# Re: Oak Creek Condominiums Public Hearing - Tuesday, April 15th

We received the Notice of Public Hearing and have reviewed the preliminary drawings available through the Development Project link on the RHS website. We are submitting these questions in advance of the hearing which we will be attending on Tuesday.

Preliminary Site Plan (C2.1) and Preliminary Utility Plan (C4.1):

C2.1 GES PROJECT # 20-0102

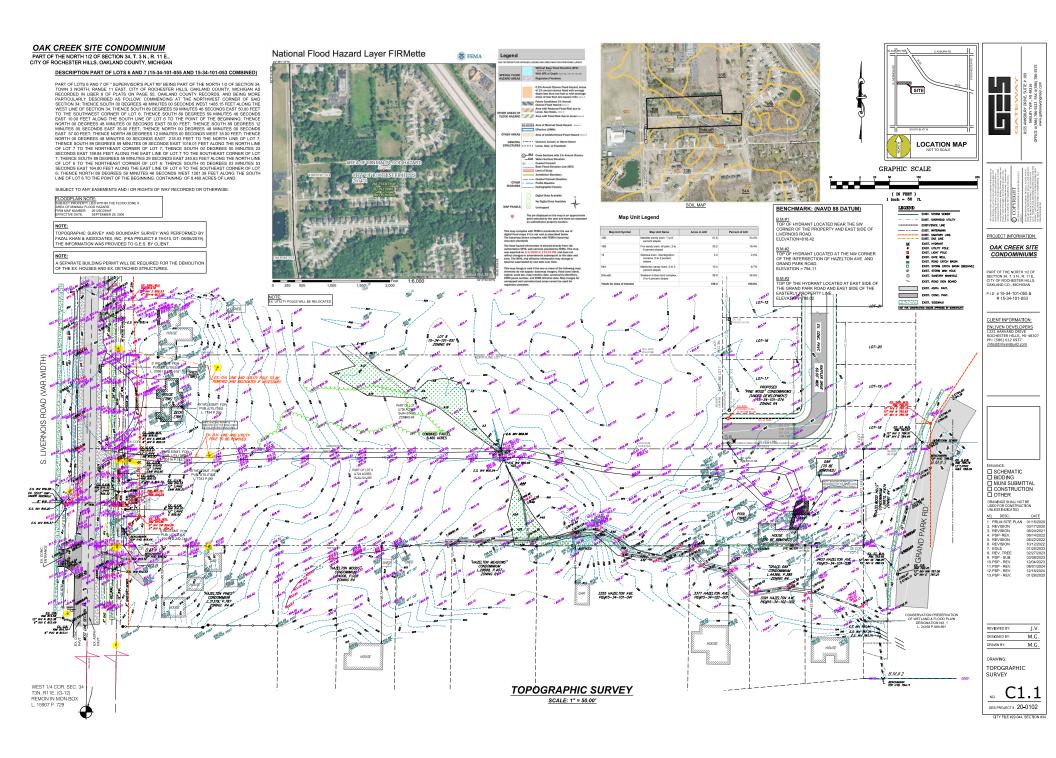
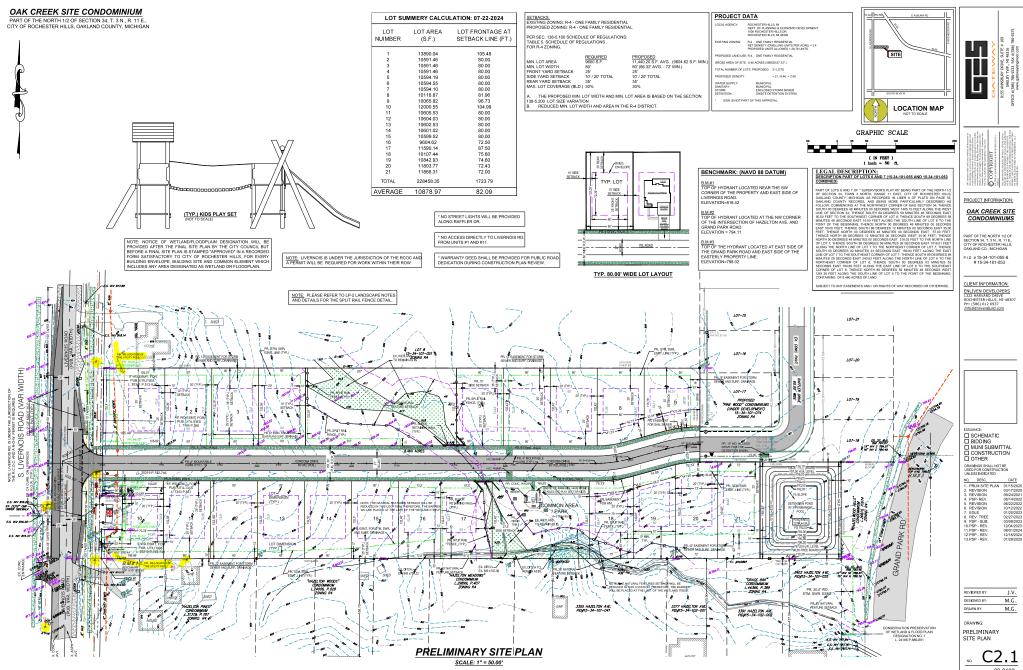
There appears to be existing utility poles missing from the drawings. Specifically, there are two poles (one on the north and south side of 3249 S. Livernois) that have power lines delivering DTE and WOW service to the southeast corner of our home at 3239 S. Livernois. These poles also currently have lines running to 3249 S. Livernois which is planned for demolition. How are the poles and lines going to be reconfigured to prevent undue disruption and undesirable line routing to our home? GES: The utility pole symbols were somehow not printed due to layer/color issue of the topo survey preparer. Please find the attached Survey sheet for reference.

Please find attached a PDF containing the topographic survey and site plan, where I've highlighted the utility pole symbol for easy identification.

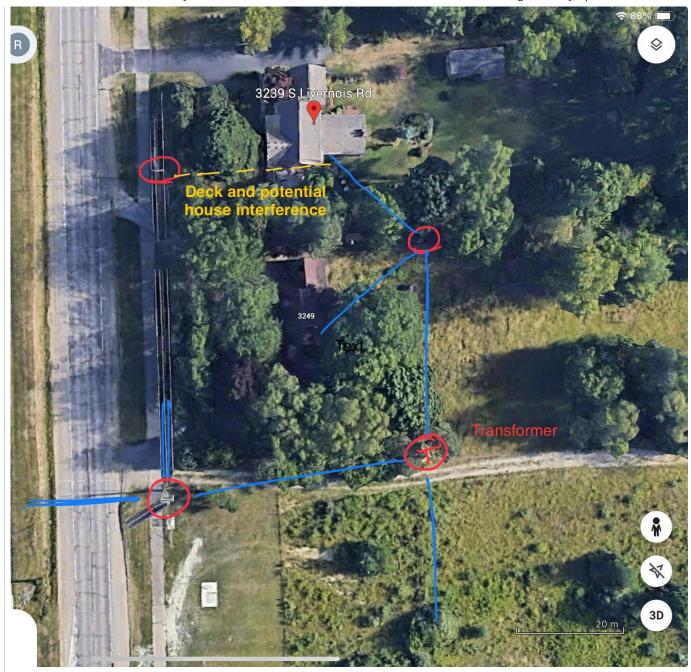
This proposed routing is going to be a big issue for us. Bringing a power line from that front pole directly to the back of our house will mean that we have a low hanging, high voltage power line over our small shed and deck. There also may not be a direct line of sight to the corner of the house above the meters where the line attaches today. I have attached a quick google earth mark up as a visual.

This is a very big safety concern for us not to mention the aesthetic impacts. We request they look at alternatives including possibly going underground.

I always recommend that you bring up whatever concerns/comments you have. That is the purpose of the meeting. However, please note, that with these ultimately being the jurisdiction of DTE we dont always have a say about where poles/lines end up being run. But that conversation can at least be started and the applicant can see if there are potential alternatives.
